UNITED STATES PATENT AND TRADEMARK OFFICE

APPLICATION NO.	FILING DATE	FIRST NAMED INVENTOR	ATTORNEY DOCKET NO.	CONFIRMATION NO.
10/064,380	07/08/2002	Michael L. Beigel	P313D	4017

Office Action Summary

EXAMINER'S RESPONSE

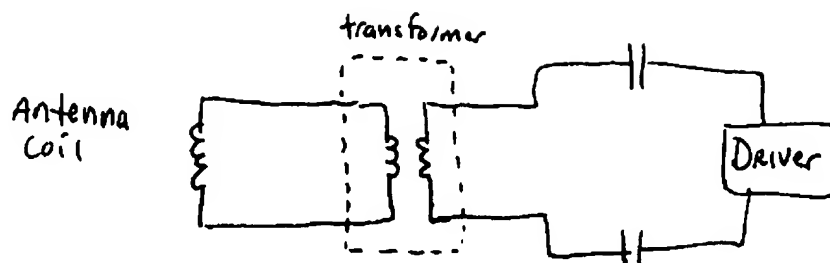
Chatelot shows a reader for communicating to a "tag", see figure 2. Chatelot shows the reader including a coil 13, two capacitors 19, a means for coupling the capacitor to the coil 24, a means to drive the coil with a driving signal 37, a mean to generate the driving signal 36, and a means to extract data from the tag 22. The tag includes a power extractor as well as a data extractor, see col. 2 lines 55+ and includes a transmission reception coils the same as the associated reader (see col. 2 line 53) , as illustrated simply in the following figure.

Chatelot does not expressly show connecting the capacitor to the coil and other circuits using a transformer as claimed and illustrated simply in the following figure.
